RE: Case No. CF 12-1269 /2111-2139 South Pacific Avenue/ (Item No. 20 on the
Committee's August 2, 2022 Agenda)

**Re: Appeal of Conditional Use, Density Bonus and Site Plan Review at 2111-2139
S. Pacific Ave; CPC-2019-4884-CU-DB-SPR-RDP and ENV-2019-4885-CE;
Appeal Case No. CPC-2019-4884-CU-DB-SPR-1A**

**To: The Honorable Planning and Land Use
Committee of the Los Angeles City
Council**
From: Douglas Kim, AICP
CC: Planning Staff and Dale Goldsmith
Date: August 2, 2022
**Re: 2111-2139 Pacific Avenue/ Response
to Comments (Case Nos. CPC-2019-
4884-CU-DB-SPR-RDP and ENV-2019-
4885-CE)**

Upper Level Parking Plan

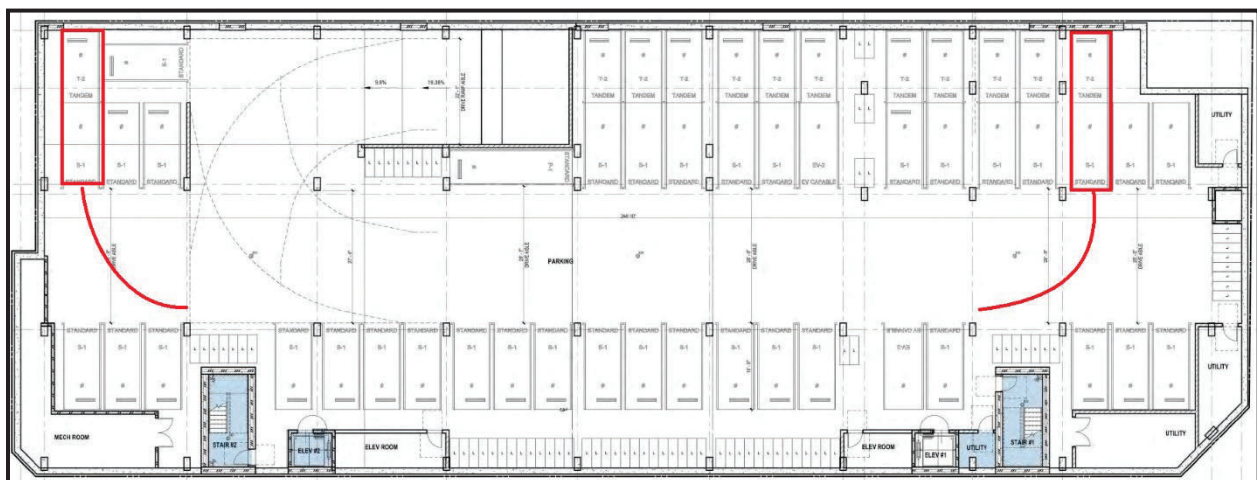
As shown in the Upper Level and Lower Level Parking Plans, several pairs of tandem parking spaces lack adequate space for the shuffling of cars. In each case, the rear tandem vehicle has space to back into, but the front tandem vehicle is obstructed and cannot complete its maneuvers to exit the tandem parking space. It is clear from the arrangement of these spaces that there is insufficient space for an 8 foot wide and 18 foot long queuing space due to the location of tandem spaces in the corners of the garages.
